City of Biddeford
Staff Review Committee
August 21, 2023 9:00 AM Second Floor Conference Room & Zoom
<https://biddeford.zoom.us/j/93209050025?pwd=Z056UHZKNFFxZDB4NFVOSIN1NGdmUT09>
Webinar ID #932 0905 0025 Password 237178

- 2.1. 2023.38 Public Meeting to review and take comments regarding a Site Plan Application for Neil's Motors to build a 3,000 SF addition to their existing building. Property is located at 602 Alfred Street (Tax Map 2, Lot 5) in the B2 Highway Business Zone.

- 2.2. 2023.37 Public meeting to review and take comments regarding a Site Plan Application for Genest Concrete to build a 1,085 SF addition to their existing building. Property is located at 544 Elm Street (Tax Map 14, Lot 4 & 5) in the B2 Highway Business Zone.

RE: 2023.38 Site Plan Application for a 3,000 Sq. Ft building addition for Neil's Auto at 602 Alfred St. (Tax Map 2, Lot 5) In the B-2 zone.

SHEET 3 OF 5

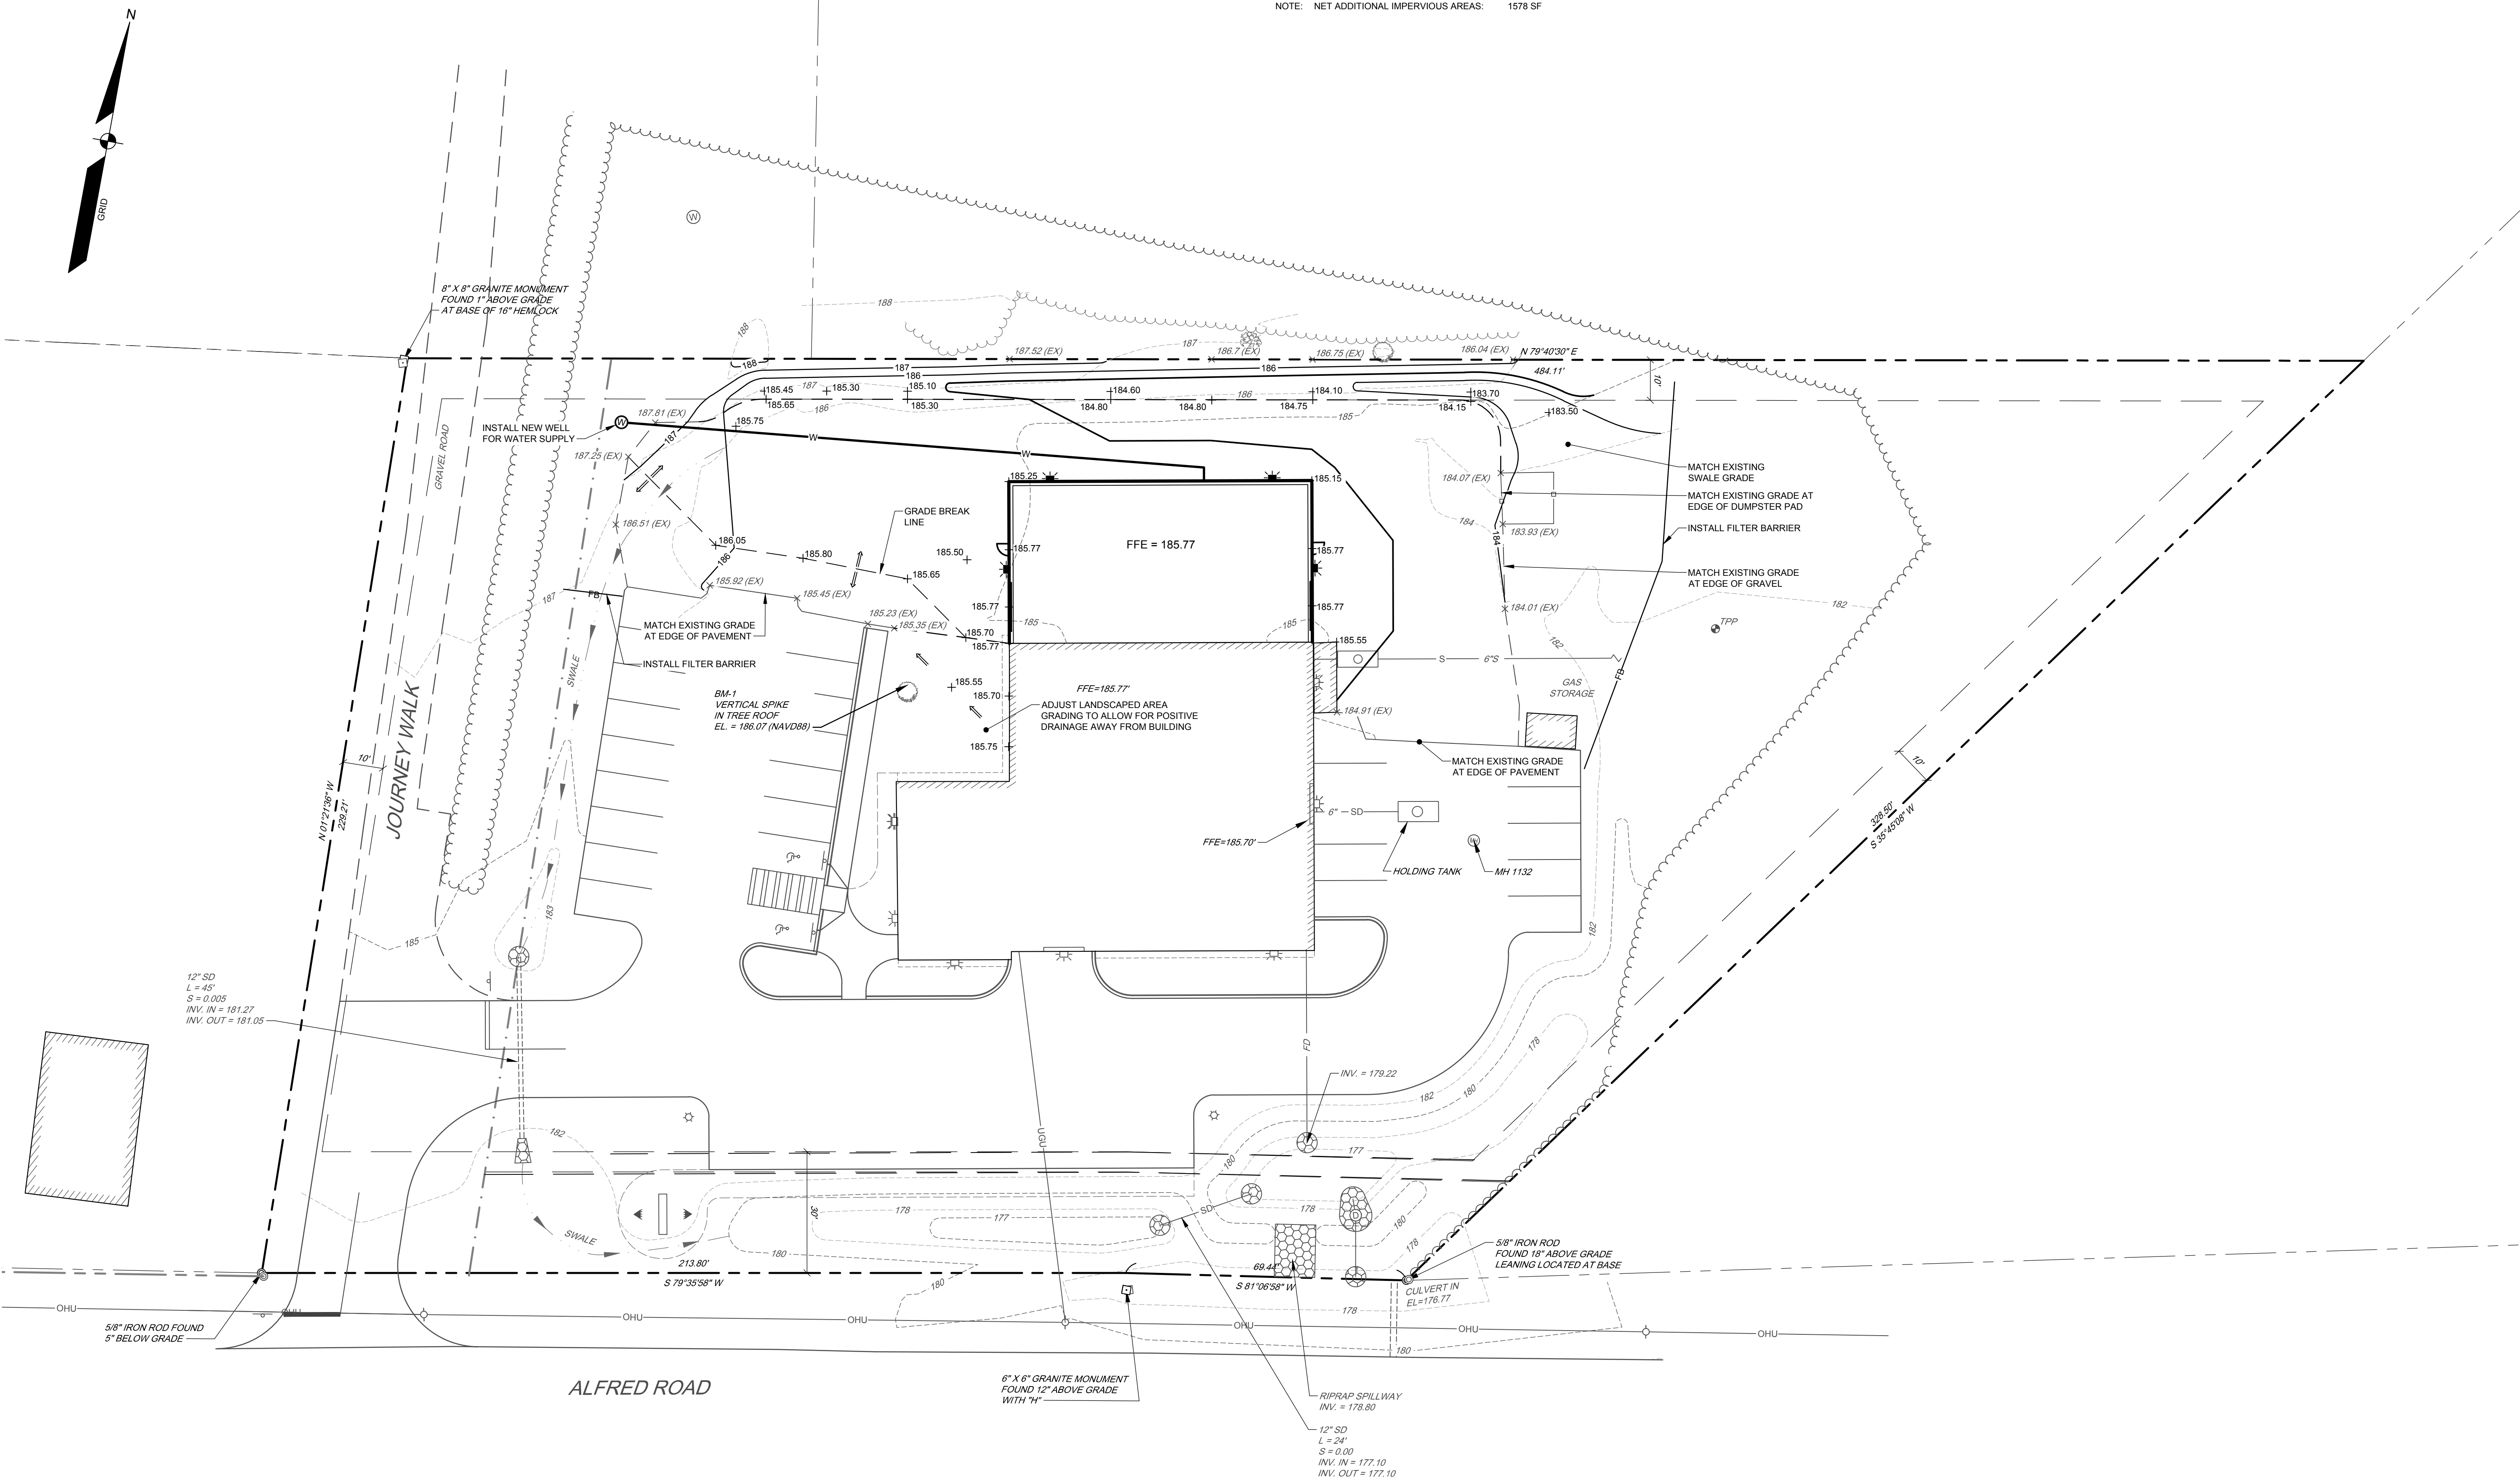
- The narrative says that the stormwater flows to existing ditches. Please provide the location of these ditches on the site plan and also provide flow direction arrows.
- Will additional gravel be installed at the rear of the new building addition, plan is not clear, there are two sets of dashed lines
- Please provide the areas for the increase and/or decrease in impervious areas proposed and net amount

- 1. the narrative says that the stormwater flows to existing ditches. Please provide the location of these ditches on the site plan and also provide flow direction arrows.*
- 2. Will additional gravel be installed at the rear of the new building addition, plan is not clear, there are two sets of dashed lines*
- 3. please provide the areas for the increase and/or decrease in impervious areas proposed and net amount*

SITE PLAN
OF:
GENEST CONCRETE IMPROVEMENTS
944 ELM STREET
BIDDEFORD, ME
FOR:
GENEST CONCRETE WORKS INC.
38 WILSON STREET P.O. BOX 151
SANFORD, ME 04073

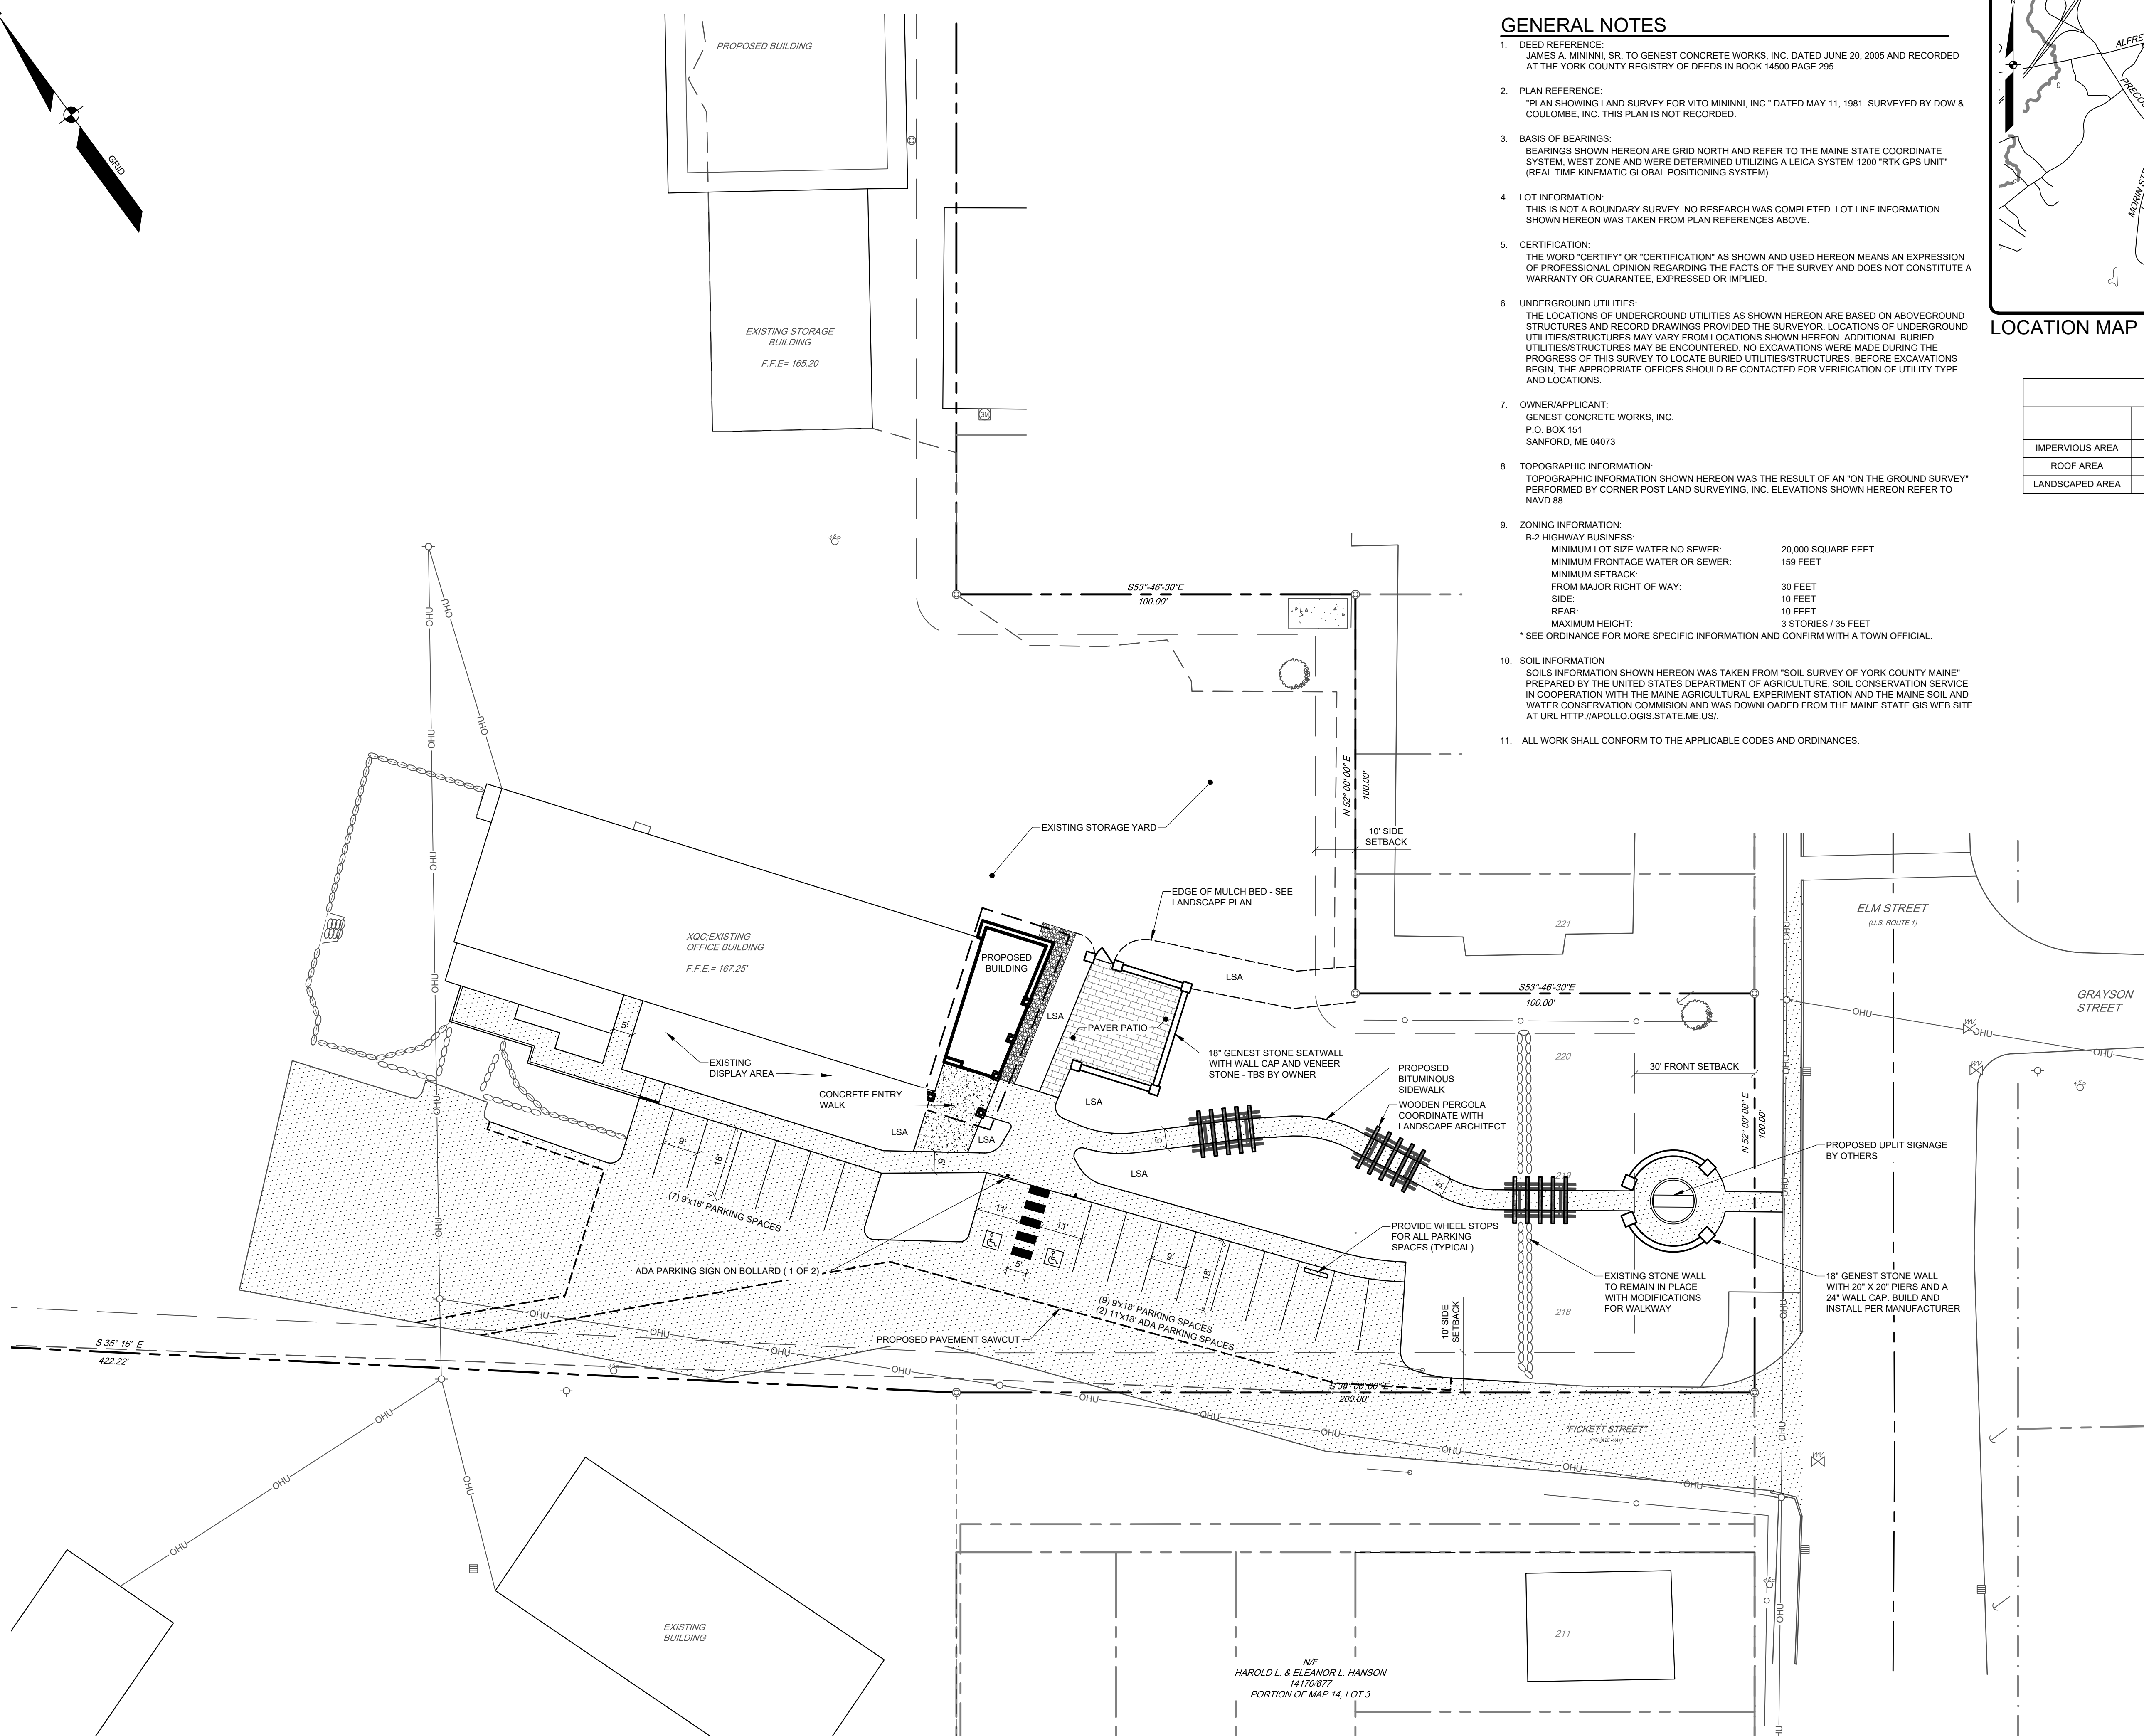
- The table in the narrative mentioned that a non-roof impervious area was removed. I do not see on the site plans the location of where that area was removed, or additional landscaped area installed, please provide more detail
- The narrative indicates that the impervious area of the site is reduced. Please provide documentation of such and a narrative explaining
- I see that catch basins and a pipe outfall is provided with an outlet at the left rear property line. How will the flow offsite be managed?
- Is there permission to discharge onto the abutting property? Since I did not see an existing conditions plan, please provide drainage calculations to indicate the proposed drainage patterns.
